**H***Alouette*313  
316  
318  
319

N° 05.69

**SUBJECT : TIME LIMITS**

Inspection of forward transmission deck attachments.

SHEET 1

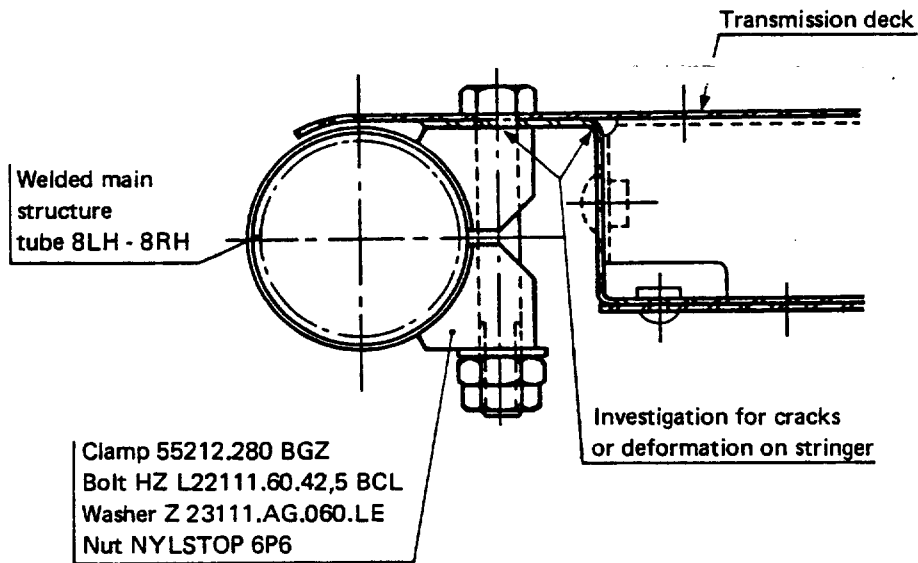
**C - DESCRIPTION (See Sheet 1)**

In order to avoid that the development of fatigue cracks at the forward attachment clamps P/No 55212.280 BGZ of the 'Z' stringer of transmission deck leads to sagging of the transmission deck in the fixing area of the flying control relay lever support, embodiment of the following measures is now mandatory :

(2) Inspection under the transmission deck

At the forward attachment clamps :

- (a) visually check that there are no cracks or deformation on the lower side of the stringer.
- (b) Make sure that there are no cracks in the inner bending radius of the stringer, by carrying out a die penetrant inspection.

## (aa) If no crack or deformation is found :

- restore the transmission deck installation in compliance with Service Bulletin No 53.32 (addition of 2 central clamps).

## (ab) If cracks or deformation are found :

Before undertaking the next flight :

- replace the 'Z' stringer by a stringer with the same P/No
- or
- replace the transmission deck.

2- Regardless of the solution embodied, restore the correct mounting of the transmission deck, through adding 2 central clamps upon the first inspection.

If cracks or deformation are found :

- Replace the 'Z' stringer by a stringer with the same P/No
- or
- Replace the transmission deck.
